RESPONSE TO REQUEST FOR FURTHER INFORMATION

Glenorchy City Council – PLN-26-239

Project	Proposed Change of Use and Internal Fit-out to Retail Grocery and Butcher Shop
Site	2 Pierce Street, Moonah TAS 7009
Applicant	
Tenant / End User	Aama Asian Grocery
Council RFI	Letter PLN-26-239 dated 29 September 2026
Traffic / Parking Report	ML Traffic Engineers – A2617337T, Version 1.1, 11 September 2026

Figure 1: Site Layout (base drawing for the swept path analysis at Appendix A)

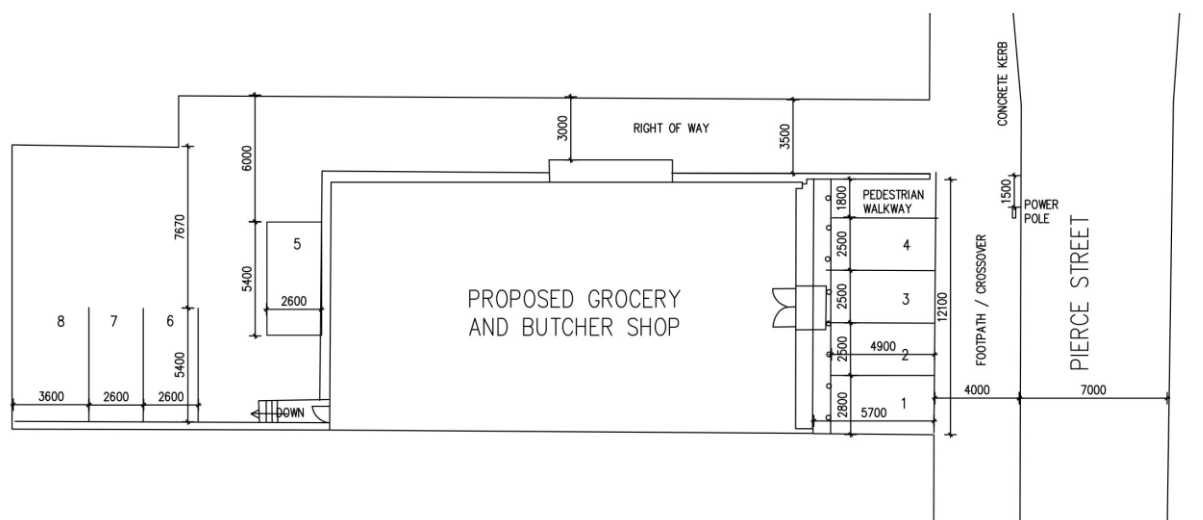
Council has requested that the drawings be amended to show pedestrian access in the middle of the frontage, between parking spaces 2 and 4. The applicant has reviewed that request against the existing site arrangement and the final ML Traffic Engineers report.

Existing electrical/power pole. The existing electrical/power pole is located within the frontage area and is already identified on the site plan. Reconfiguring the forecourt around a central pedestrian route would also affect vehicle manoeuvring in the vicinity of this existing site constraint.

Proposed response. No reduction of the existing four forecourt parking spaces is proposed. The applicant therefore proposes to retain the existing northern-side pedestrian walkway and four-space forecourt arrangement shown on the submitted plans and assessed by ML Traffic Engineers. The revised site plan will more clearly identify the pedestrian walkway, the four forecourt parking spaces, the existing electrical/power pole and the Right-of-Way.

The pedestrian walkway and Right-of-Way are to remain clear of parked vehicles, goods, waste bins and other obstructions.
